Community Solar Project Interconnection
Tier 2 Community Solar Project Report

("Applicant")
CSPQ005

Proposed Interconnection
On PacifiCorp's Existing
Circuit 5W26 out of the Enterprise substation
Map String 01402044.0, Facility Point #030606

May 18, 2020

Figure 1: System One Line Diagram

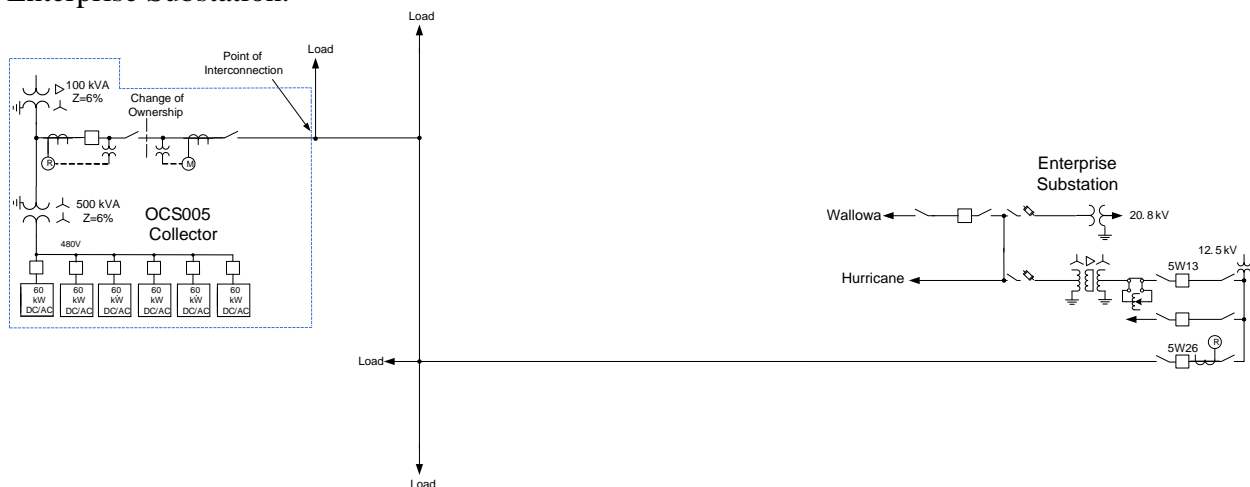
The existing distribution system is a 12.5 kV three phase, four wire primary line. The project one line indicates a line to neutral grounded Wye primary on the medium voltage transformer, effective grounding will occur with an adequately sized grounding

transformer.
